SHOP DRAWINGS — ELECTRICAL / AGL SCOPE

RECTIFICATION OF TWY E BETWEEN E4 & E6 (ADIA)
AGL WORKS AT THREE (3) MILLING LOCATIONS — FIELD CONDITION SCOPE

Document No.	[XXX-ELE-SHD-1001 / 1002 / 1003] · Revision P06 (EDITABLE ISSUE)
Basis of scope	Field verification sheets: Document_3 (LOC-01) · Second_milling_area rev _1 (LOC-02/03) · Duct geometry: ADA drawing Z1-Z2-Z3-MTA_SEGMENTATION.dxf
Base layer	As-built AGL fitting positions (per assets_20260726120533.xlsx). AS PLOTTED they are ZIA LOCAL PROJECT GRID (m), matching the ADA source drawing to sub-millimetre — NOT UTM 40N. The Rev P05 EPSG:32640 label was incorrect — see sheet 6.
Prepared by	Mohammed — AGL Team Leader, ADB SAFEGATE AGL Team · Issued 28.07.2026

REV P06 — the "indicative duct" construction lines of Rev P05 (straight lines from each light to its nearest pit) are removed and replaced with the real as-built duct, ductbank, conduit and sawcut geometry from the ADA source drawing, registered onto each sheet to sub-millimetre. Every element remains a native editable PowerPoint shape. Provenance, registration residuals and limits: sheet 6.

LOCATION 1 — 1001 · REV P06 (EDITABLE)

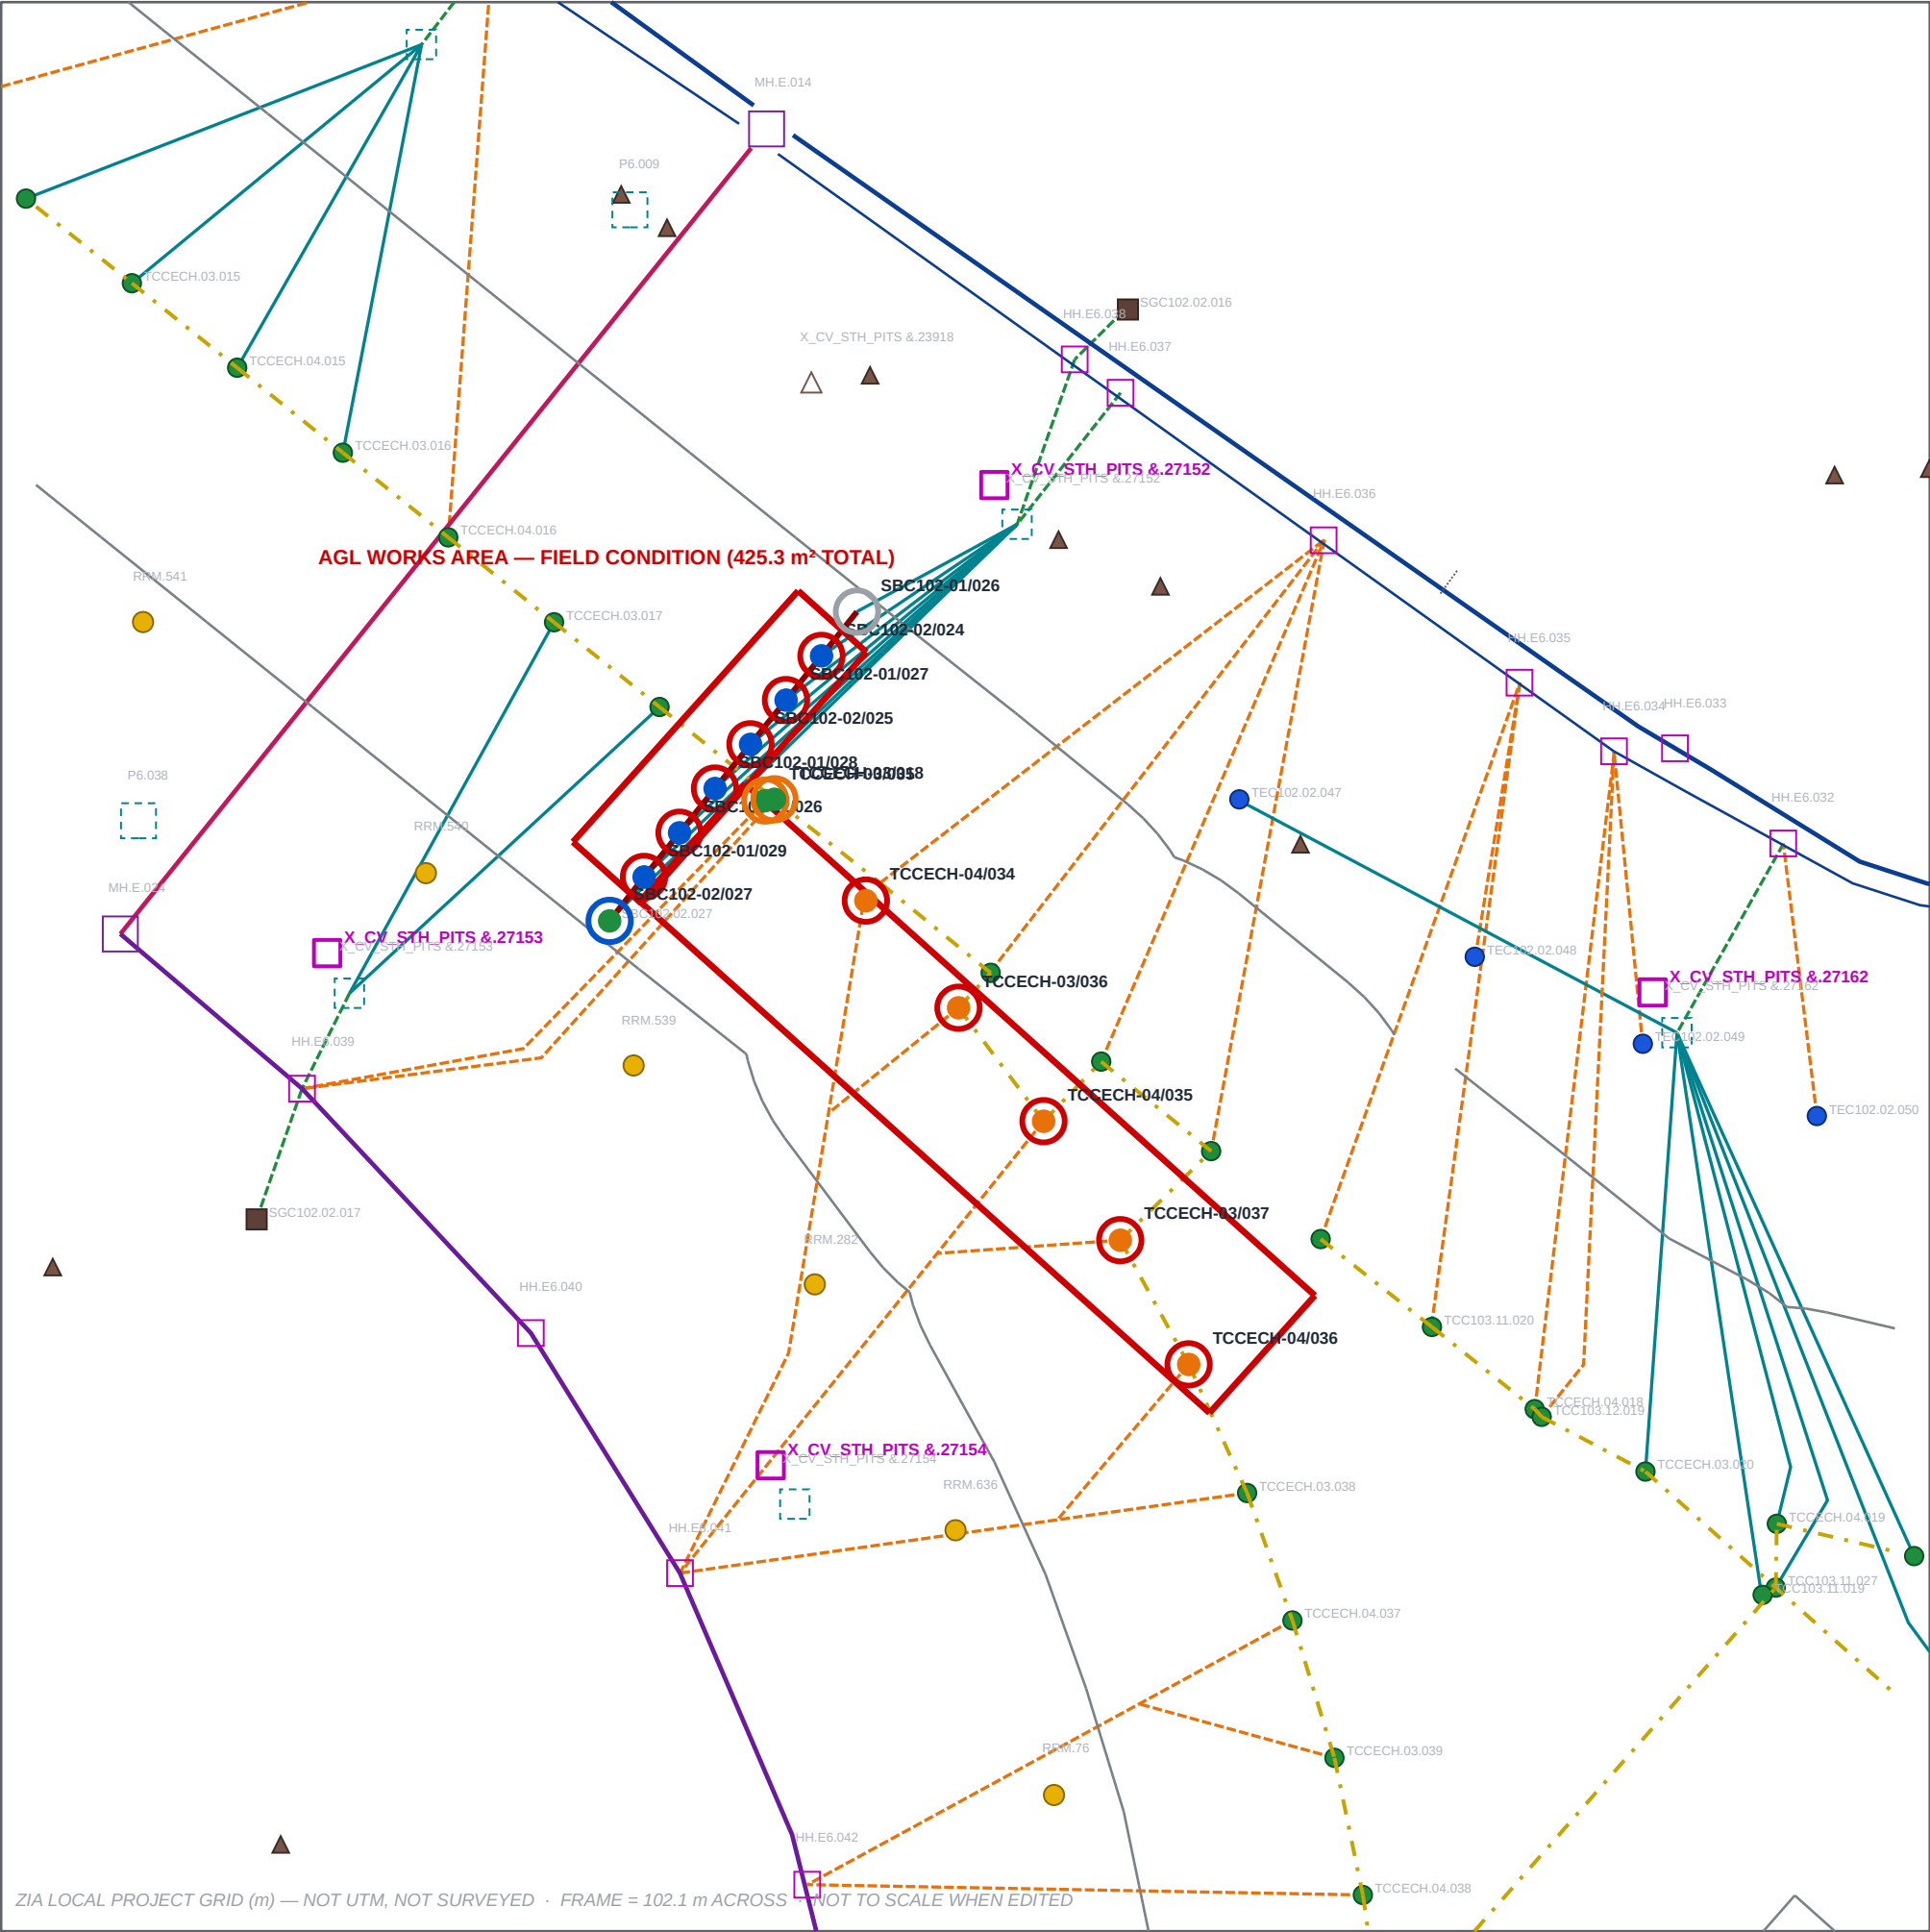
CORE OUT SHALLOW BASE + NEW CABLE: 11 No.
• VIA DUCT (6): SBC102-02/024, 01/027, 02/025, 01/028, 02/026, 01/029
• VIA SAWCUT (5): TCCECH-04/034, 03/036, 04/035, 03/037, 04/036
NEW SECONDARY CABLE ONLY: 3 No.
• SBC102-02/027 (DUCT) · TCCECH-03/035, 03/018 (SAWCUT — bases OK, verify at cut line)
FIELD VERIFIED NOT AFFECTED: SBC102-01/026 (no works)
TCC103 FITTINGS NOT IN FIELD SCOPE — SHOWN AS EXISTING ONLY
ISOLATE CIRCUITS: SBC102.01/.02, TCCECH.03/.04
SITE RECORD 23.07.2026: 9 cored + 2 reinstatement already worked

- Positions plotted are ZIA LOCAL PROJECT GRID metres — NOT UTM 40N. The Rev P06 "EPSG:32640" label was wrong; no surveyed local-to-UTM transform exists. Do not issue a UTM coordinate from this sheet.

- AGL works area (red) per field condition. Coring at Location 1 only.
- Duct / ductbank / conduit / sawcut lines are REAL as-built geometry from ADA drawing Z1-Z2-Z3-MTA_SEGMENTATION.dxf — not light-to-nearest-pit construction lines. Layer name carries size and way-count; see sheet 6.

- Ducts are drawn as the separate segments they are in the source. Continuity NOT proven — do not take a continuous pull length off this sheet.
- Isolate, lock out & prove dead all listed circuits at CCR under permit before cutting, coring or excavation.

- HH / MH / transformer-pit / RRM symbols sit ~2.1-2.3 m off the source insertion point (sheet 6) — set out civil features from survey.
- Centerline & stop bar from as-built TCC / SBC fittings. Edge indicative 23 m — confirm on site.

LOCATION 2 — 1002 · REV P06 (EDITABLE)

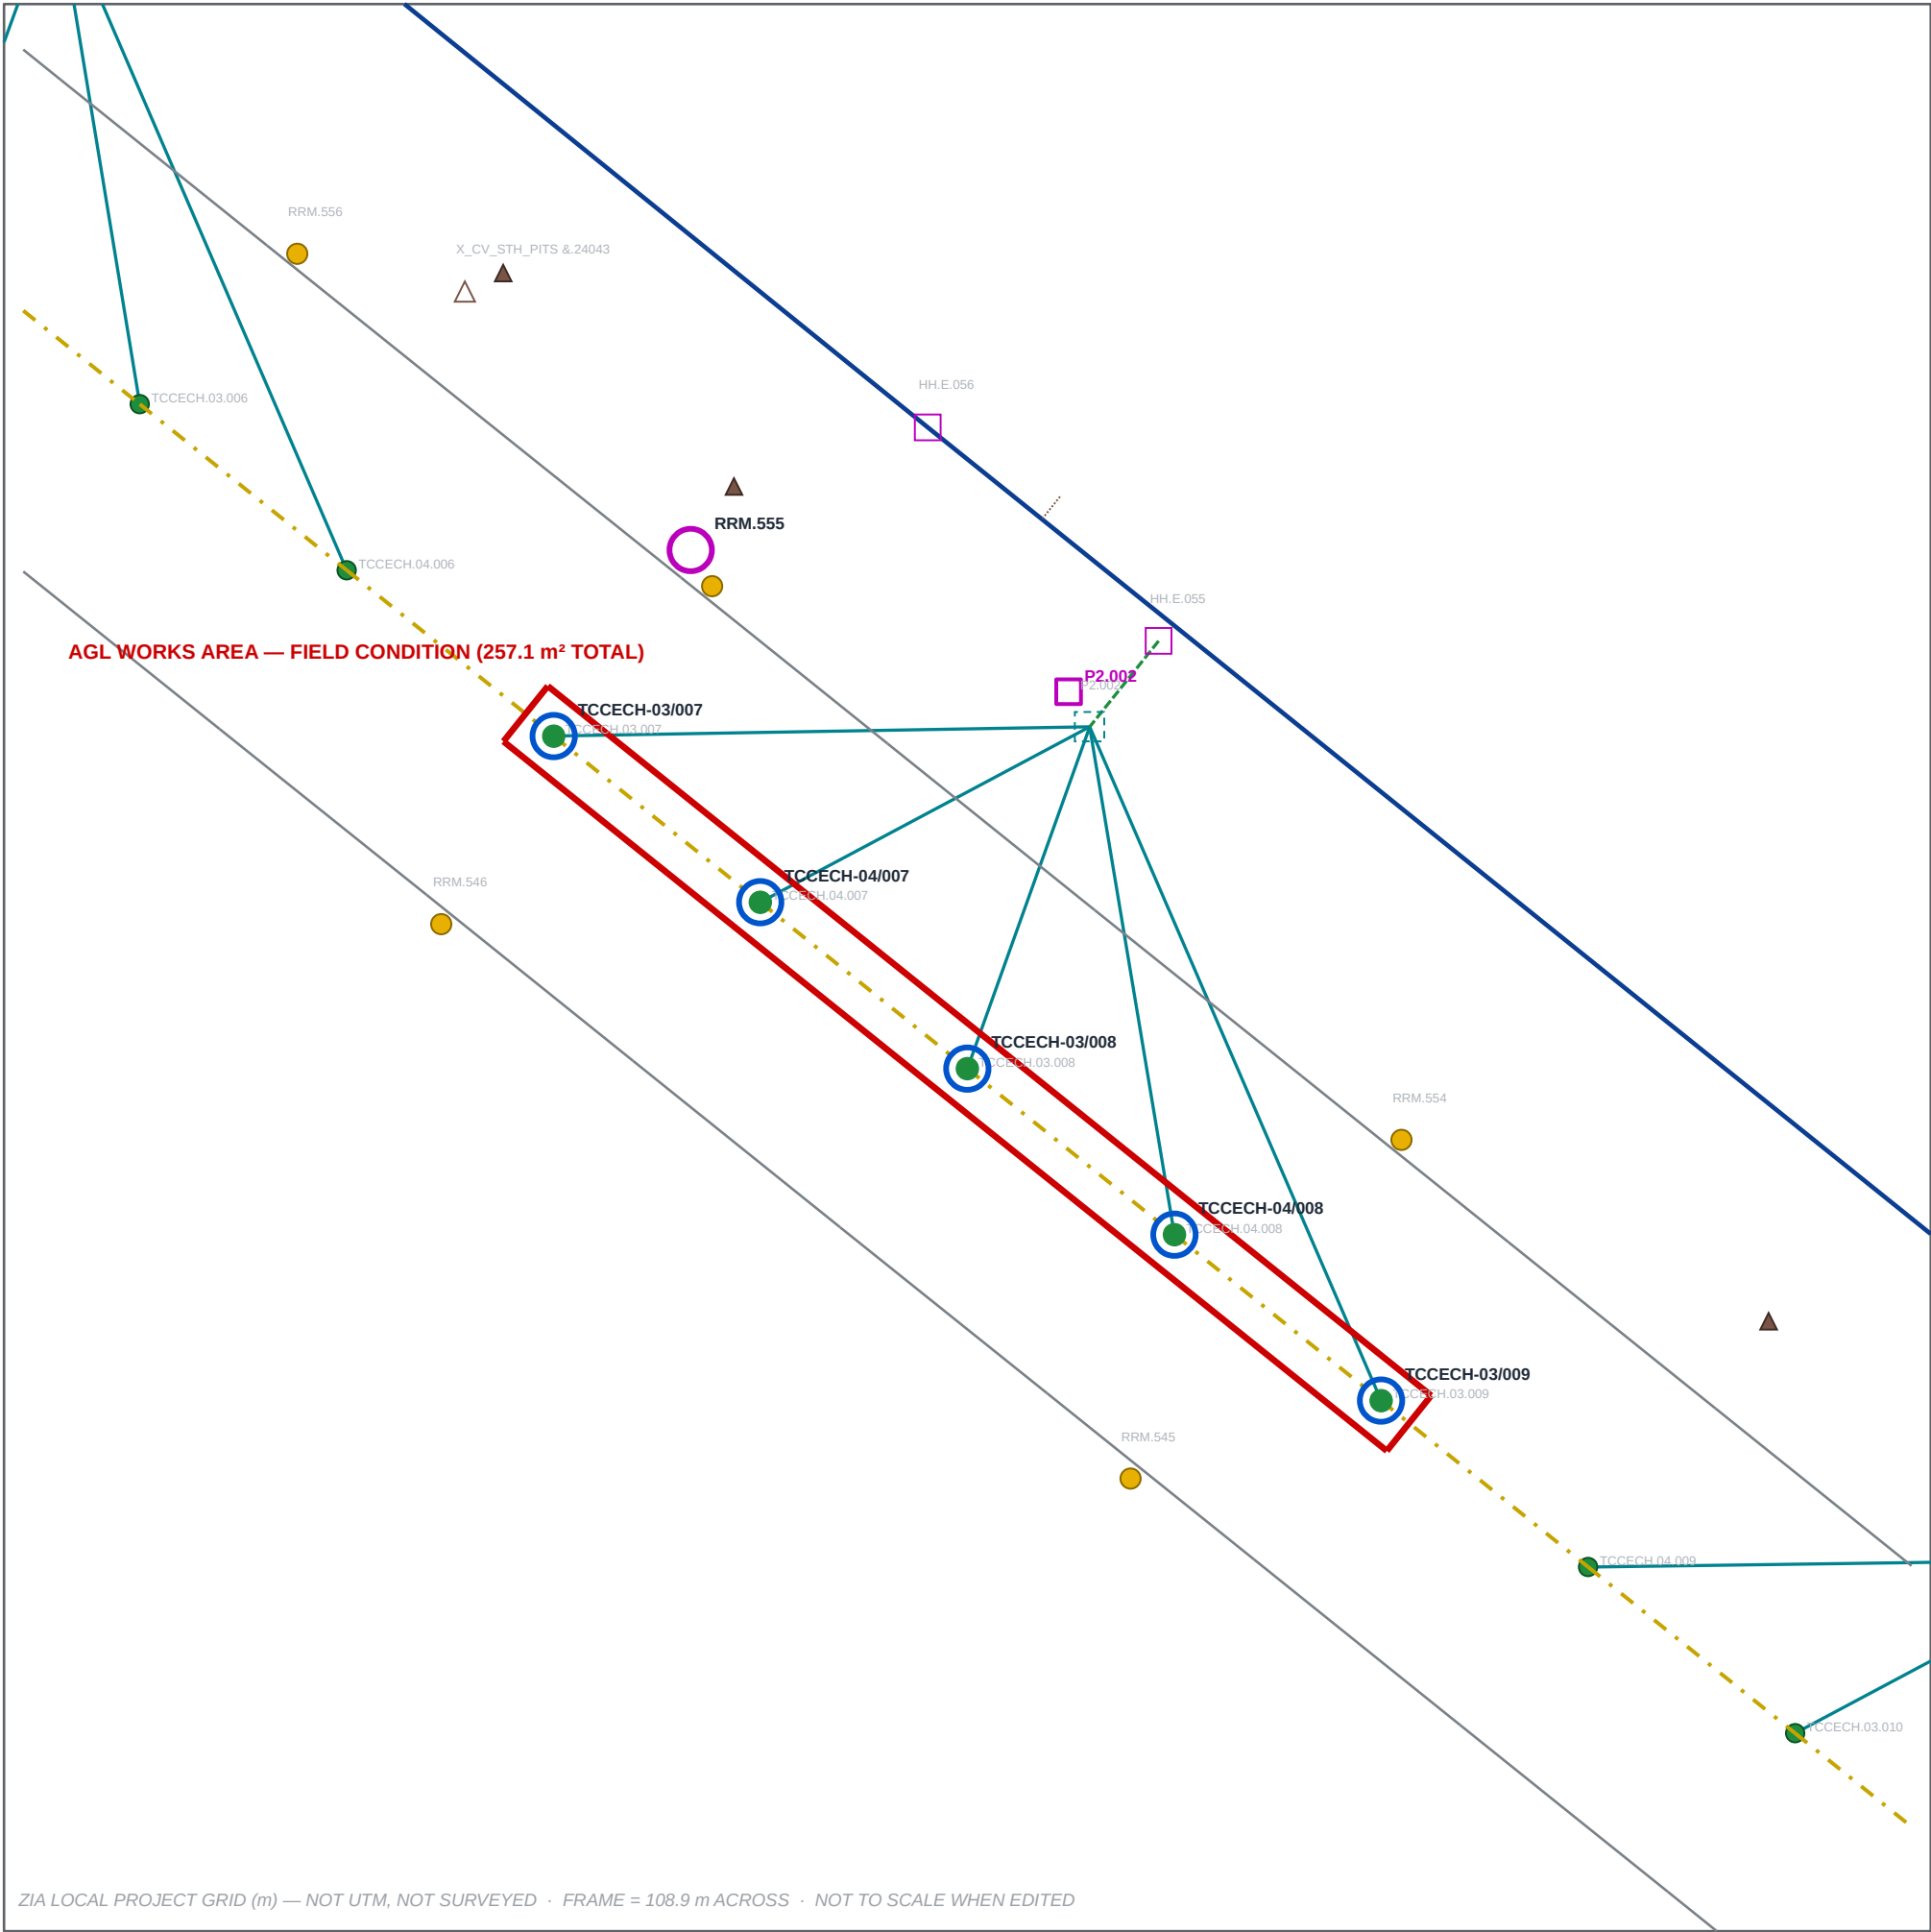
NEW SECONDARY CABLE ONLY (VIA DUCT): 5 No.
• TCCECH-03/007, 04/007, 03/008, 04/008, 03/009
NO SHALLOW BASES AFFECTED AT THIS LOCATION
SECONDARY DUCT (AS-BUILT): 5 SEPARATE HOME RUNS FROM ONE TRANSFORMER
HANDHOLE — NOT A CHAINED RUN. 20.5 / 21.1 / 29.1 / 30.3 / 41.5 m = 142.5 m TOTAL. RE-PRICE — SEE SHEET 7.
(Rev P06 chained-run assumption superseded by the source drawing — see sheet 7)
RRM.555 (0.41 m from cut): REMOVE / PROTECT BEFORE SAWCUT, RE-FIX AFTER PAVING
ISOLATE CIRCUITS: TCCECH.03, TCCECH.04
